UNIRAIL / ROOFSAFE CARRIAGE - PRODUCT RETROFIT NOTICE

22 February, 2016

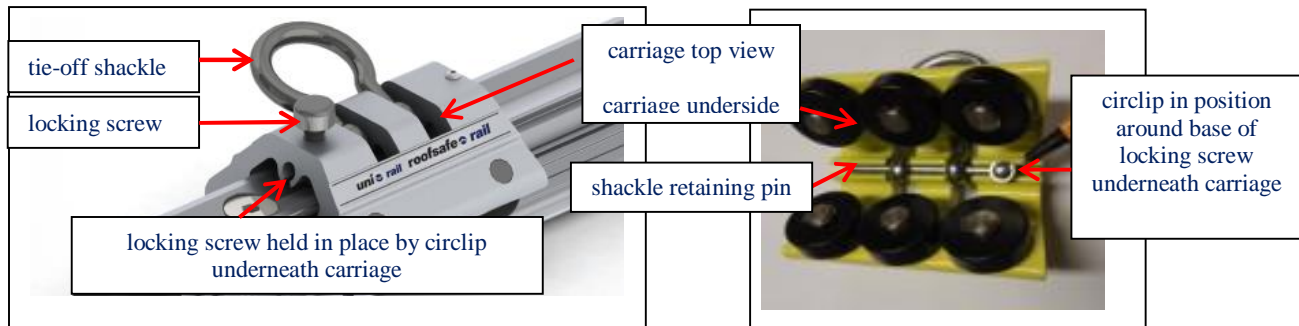
The Unirail[®] and Roofsafel[®] Rail Systems are lightweight, modular, horizontal rail systems that provide a moveable anchorage point for workers at height. Tie-off capability is provided via a tie-off shackle incorporated into the carriage component of the system as pictured below. These systems can be installed at any working level, from foot level to overhead.

Capital Safety has received a limited number of reports of fractured circlips (the locking screw retaining clips) which can allow the locking screw to unscrew and separate from the carriage body. If the locking screw separates from the carriage body, it is possible for the shackle retaining pin to slide out of the carriage body and release the tie-off shackle. We believe that user practice of permanently backing the locking screws out to allow the carriage to move freely on the rail can overload the circlips to the point of fracture over time. Only Unirail / Roofsafe carriages manufactured before February 2015 are susceptible to this condition.

There have been no reports of these systems failing to arrest a fall. However, in certain applications (e.g., overhead installations), if the shackle separates from the carriage body, it is possible that other fall protection equipment connected to the shackle (such as a self-retracting device), may fall and cause bodily injury or property damage. Accordingly, Capital Safety has developed a fixed-bolt Retrofit Kit to replace the locking screw and circlip.

NEXT STEPS: Capital Safety recommends that all users of Unirail/Roofsafe carriages manufactured before February 1st, 2015 install a Retrofit Kit. **Note, this is not a product recall.**
